Memorandum

Re: ENF Filing
Atlantic Avenue Reconstruction
Project #601607
Hull, MA

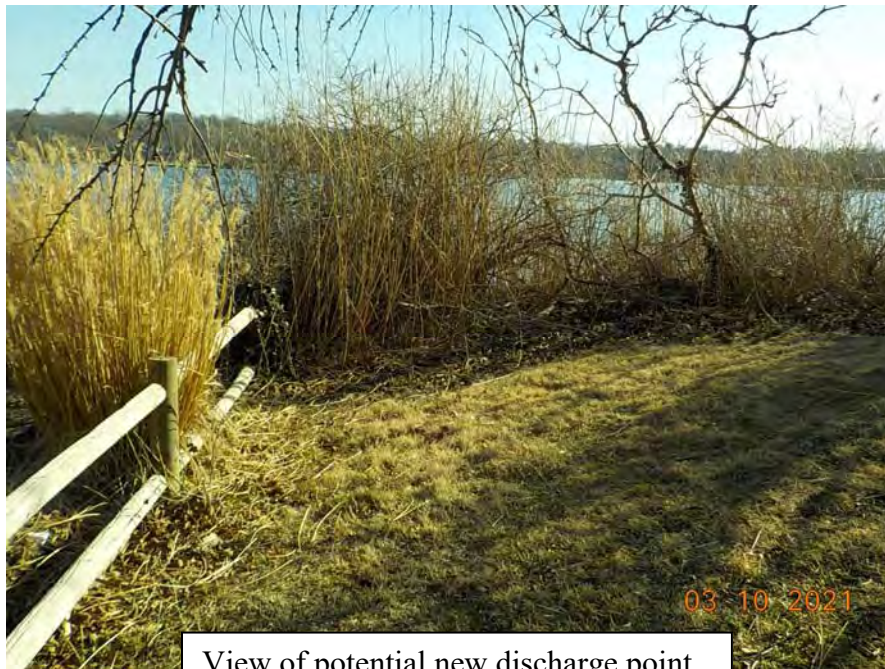
As a supplement to the previous memorandum and continued concern raised by CZM and DEP staff, we would like to provide additional details regarding the stormwater BMP's that have been considered for use along this project and the specific areas where they were considered for use.

The Massachusetts Stormwater Handbook recommends several BMP treatments for use in stormwater systems with discharges to Outstanding Resource Waters which were evaluated for this project. These recommendations for implementation on this project are discussed below. A focus on BMP's with Nitrogen, Phosphorus, and Bacteria removal are most applicable in meeting Standard #6 to the maximum extent practicable for this redevelopment project.
